**FIELD WORK VARIANCE**

Project Name/Number	140705	CTO/WAD	
Applicable Document	KAFB Groundwater Investigation Work Plan Part I: Field Investigation Activities Bulk Fuels Facility Spill Solid Waste Management Units ST-106 and SS-111	Date	January 19, 2011

Field Work Variance No. KAFB-FWV-1

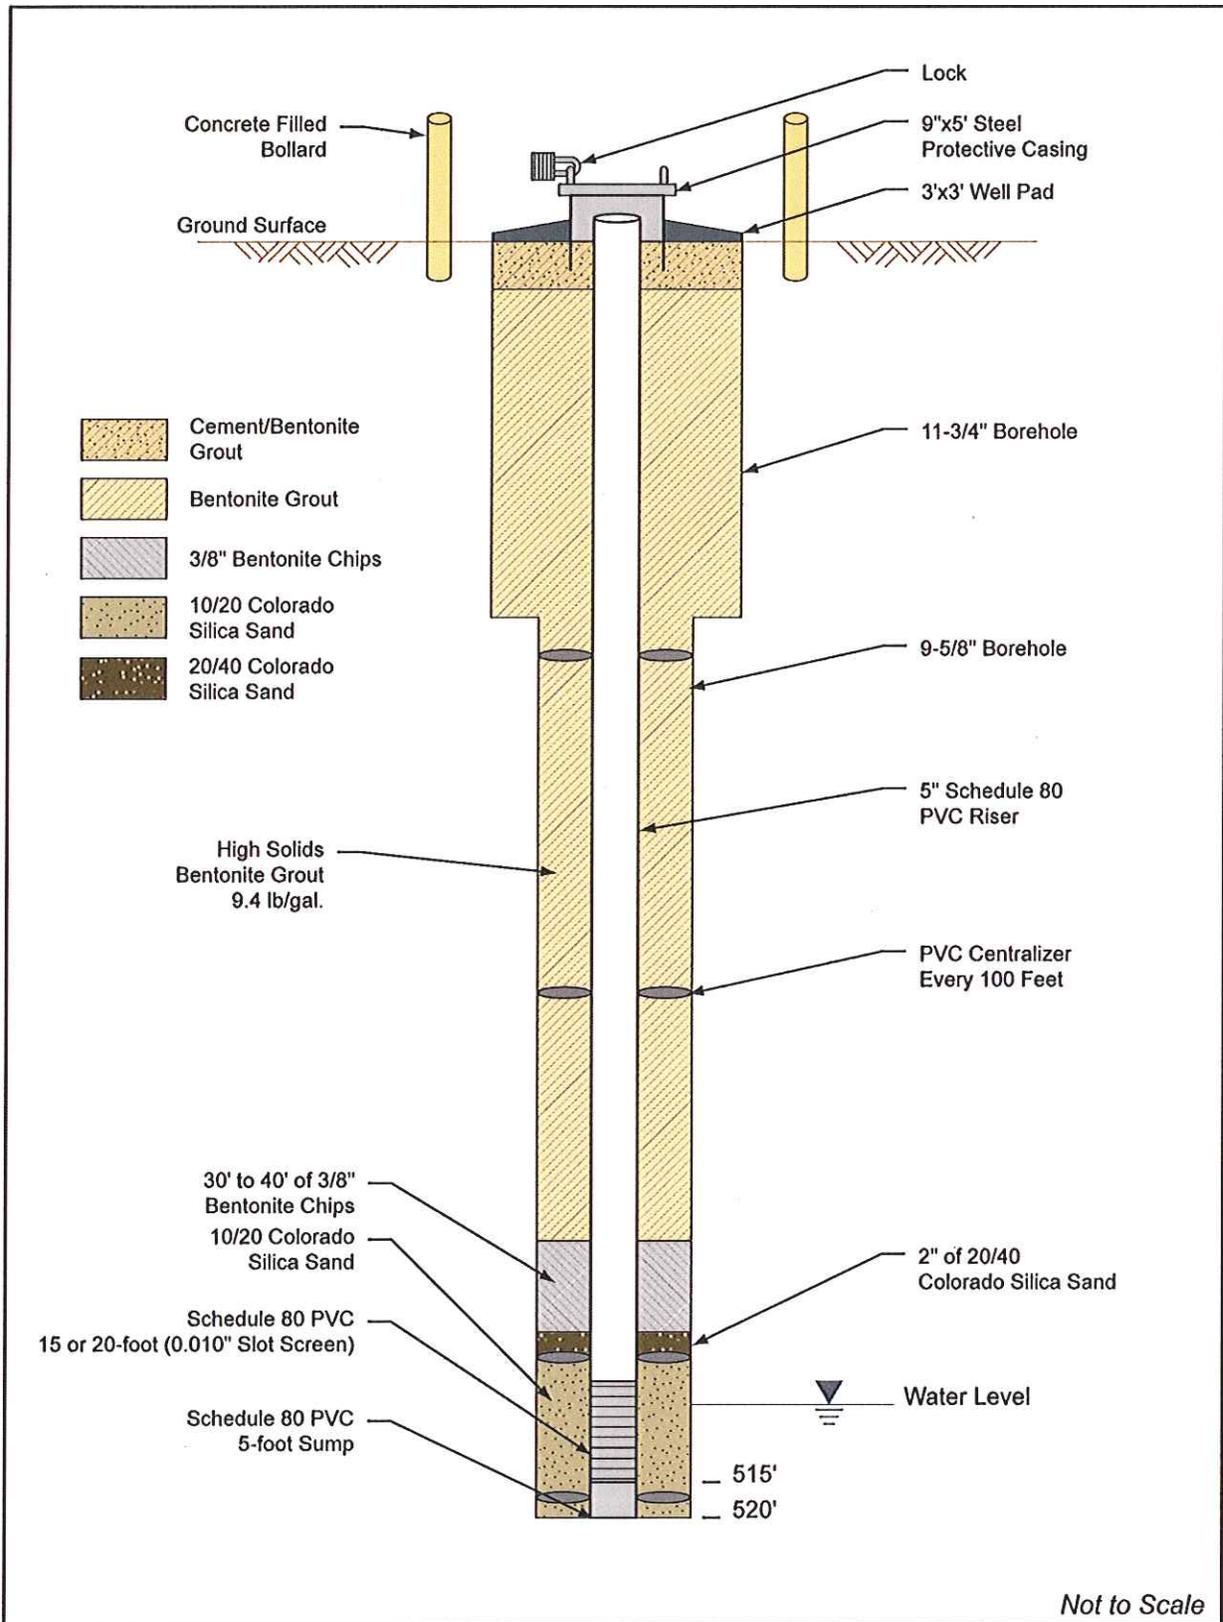
Drilling and well completion specifications procedures have been changed due to regulator direction and site specific geologic conditions.

- Work Plan Section 5.2.4.1 No. 4, replace stainless steel well screens with PVC well screens.
- Work Plan Section 5.2.4.1 No. 6, replace "PVC centralizers will be installed above and below the sump" with "PVC centralizers will be installed every hundred feet along the riser pipe"
- Work Plan Section 5.2.4.1 No. 8, replace "a bentonite seal will be installed for a thickness of 10 to 20 feet" with "a bentonite seal will be installed for a thickness of 30 to 40 feet."

A revised construction diagram is attached.
